Petition Number: Insert Zoning Petition #2021-046

From: Robyn Byers, Ph.D. Reviewer: Eric Lemieux, PE

Date	Description	
04-29-2021	First Review (EL&KP)	
05-27-2021	Second Review (EL)

### **General Review Information**

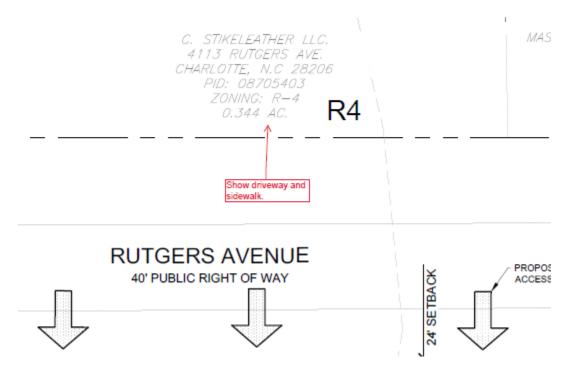
- Curb line: The proposed zoning district has a setback measured from back of the existing or proposed future curb line.
  - Rutgers Avenue: The future location of curb and gutter will be located 13-feet from the existing centerline to back of curb.

Label and dimension the curb and gutter from the centerline.
